TO: Parks and Recreation Board

DATE: May 28, 1991

**TO:** Parks and Recreation Board  
**FROM:** Manuel A. Mollinedo, Director  
Parks and Recreation Department  
**DATE:** May 16, 1991  
**SUBJECT:** Town Lake Park, Request for Easements  
South Austin Relief Main, Phase 1

SUBJECT: Request for Easements Across Parkland  
South Austin Outfall Relief Main, Phase I  
CIP No. 436 237 0395

# BOAT DOCK, LAKE AUSTIN

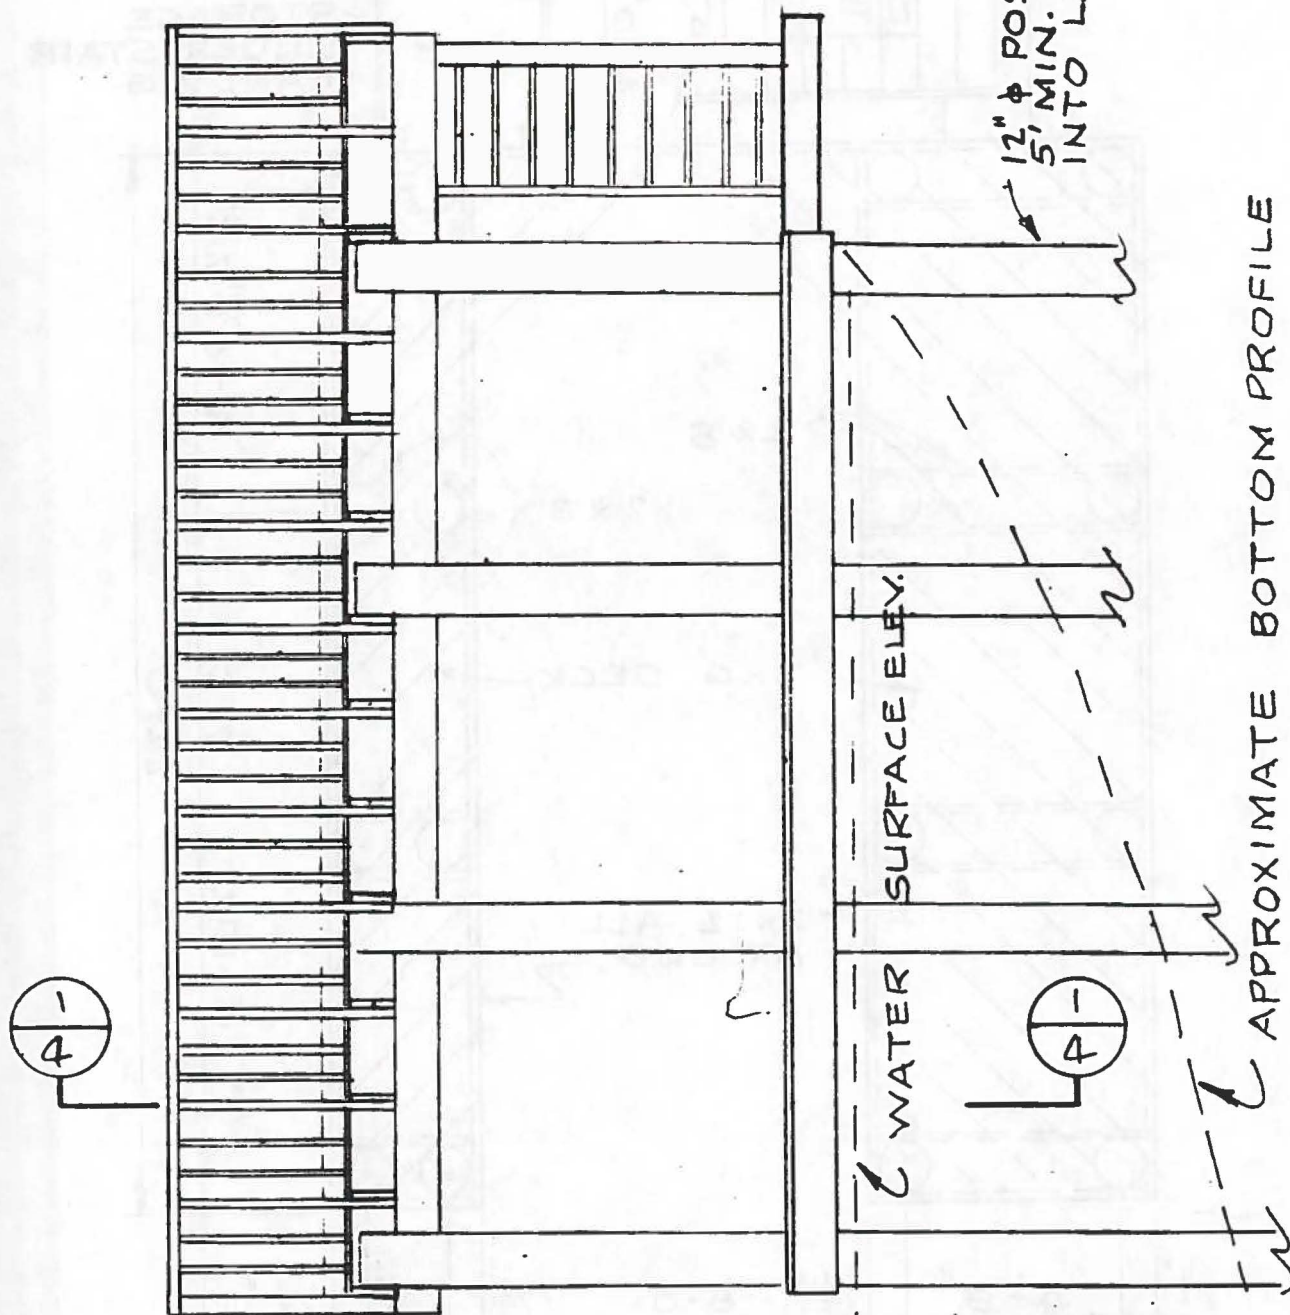
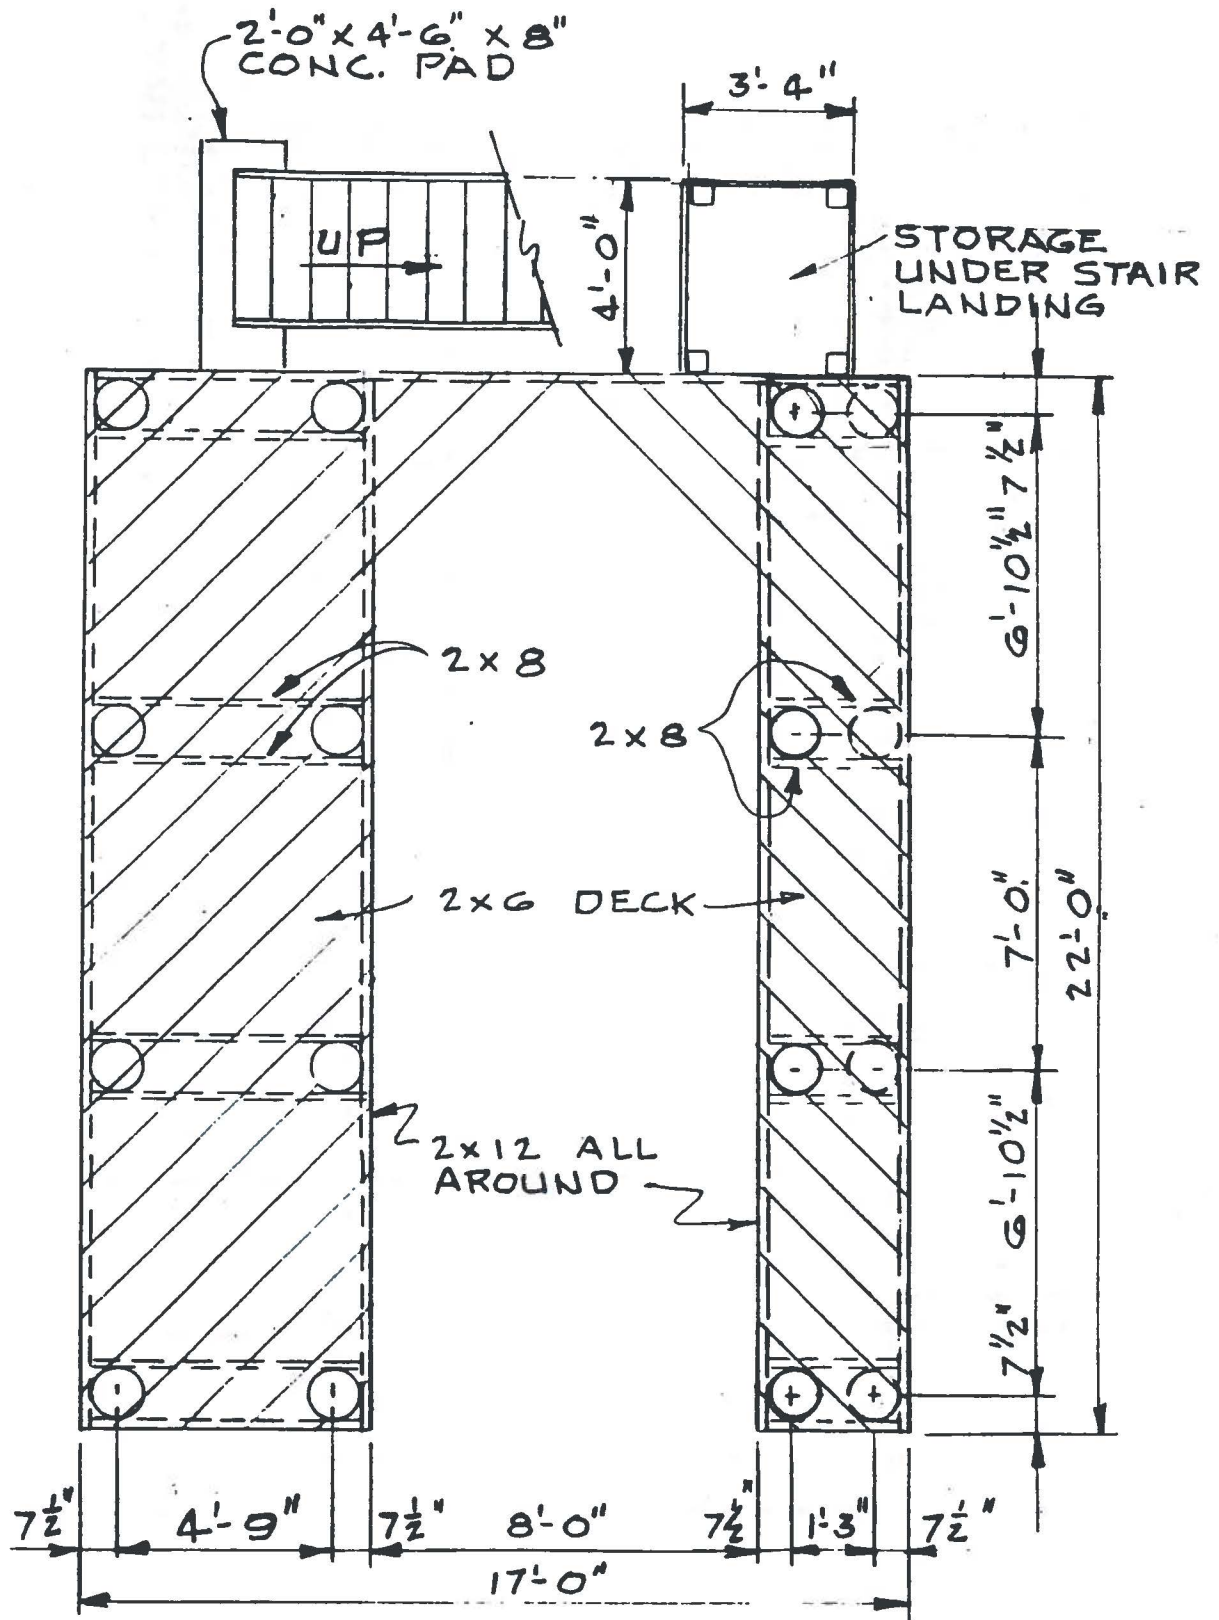
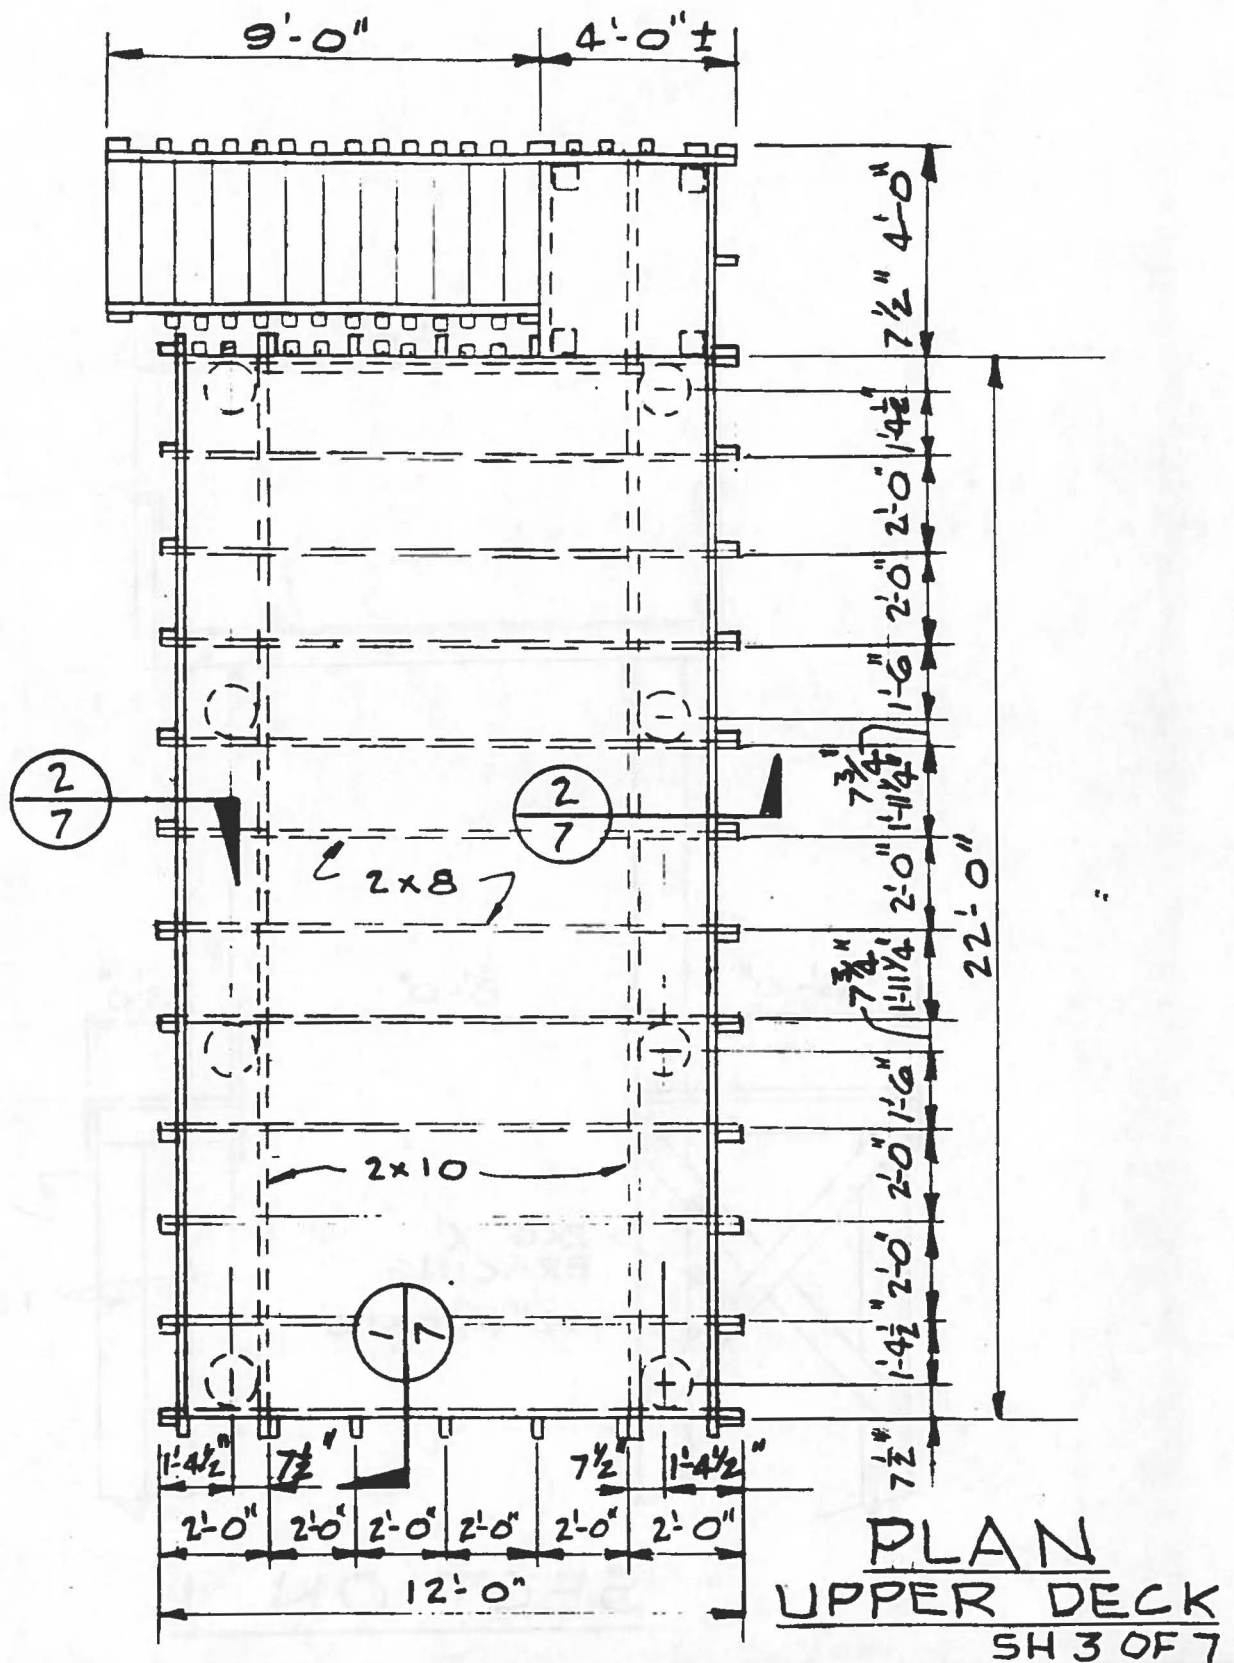
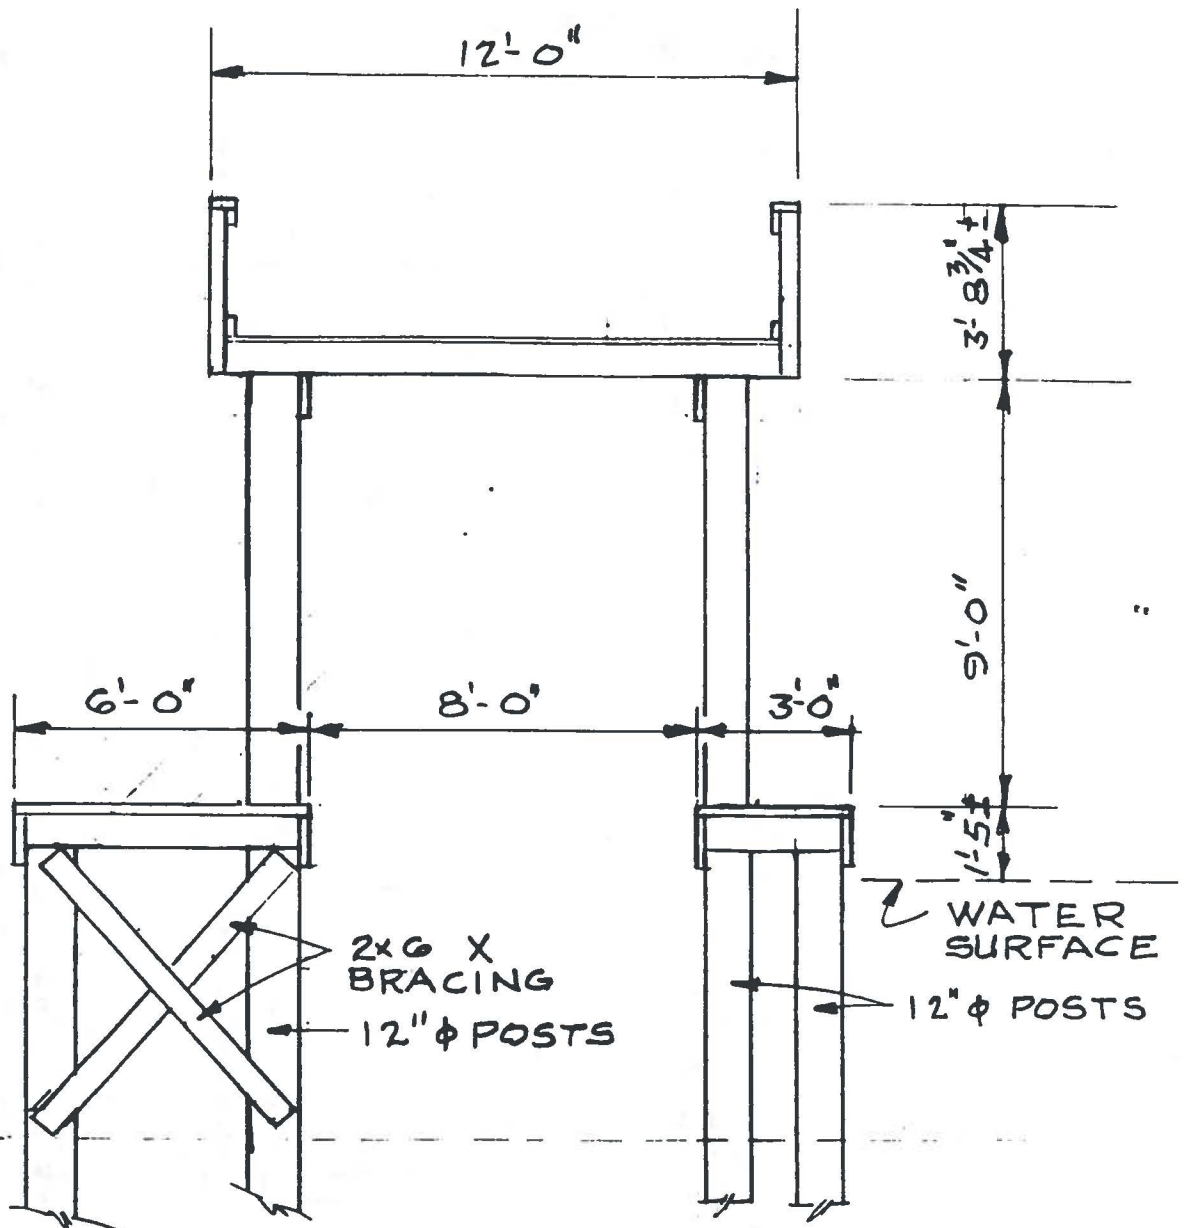
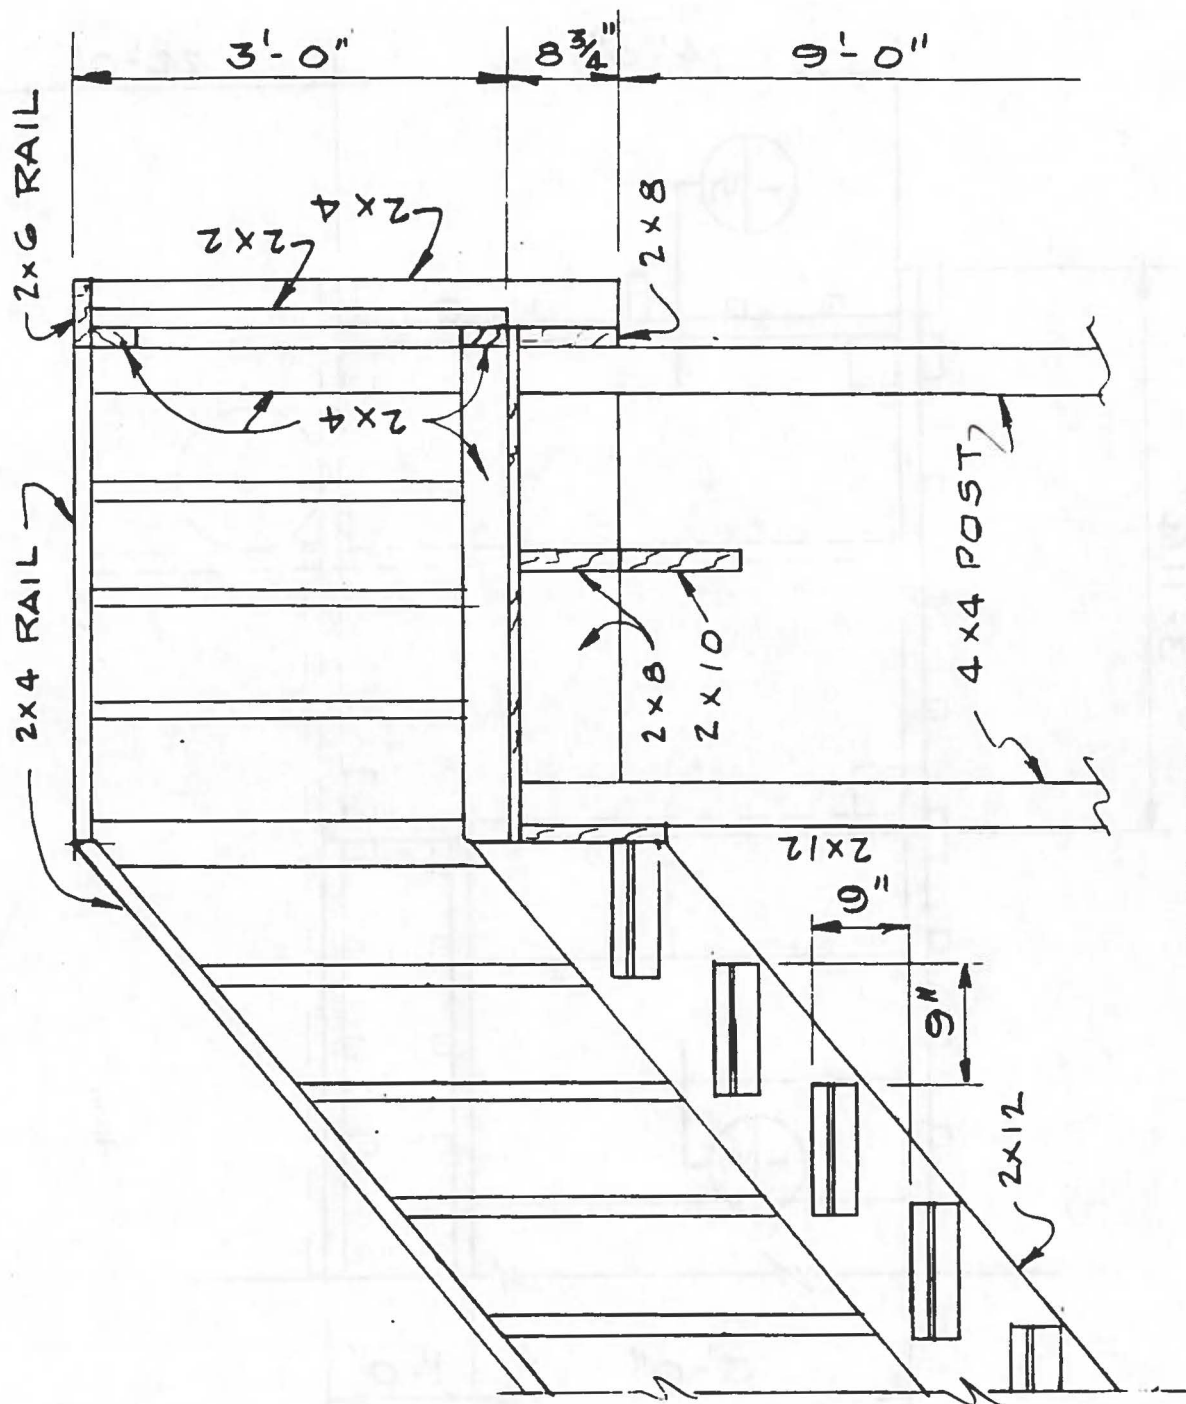
The plans for the boat dock specify Creosote treated timber for the pilings in the water; only CCA treated or natural decay resistant timber, or inert materials are permitted as pilings in the water. It is not known whether the creosote pilings have been installed.

PD 1. The boat dock plans specify Creosote treated timber, only CCA treated timber, natural decay resistant timber or inert materials are permitted as pilings in the water.

PD 6. The letter of request addressed to the Parks and Recreation Board refers to construction at 12425 riverbend, Lot 6 Freund Sleepy Hollow, with construction scheduled to commence December 1, 1984. Is this correct? If not a new letter of request for the Board to consider 12605 Riverbend is required.
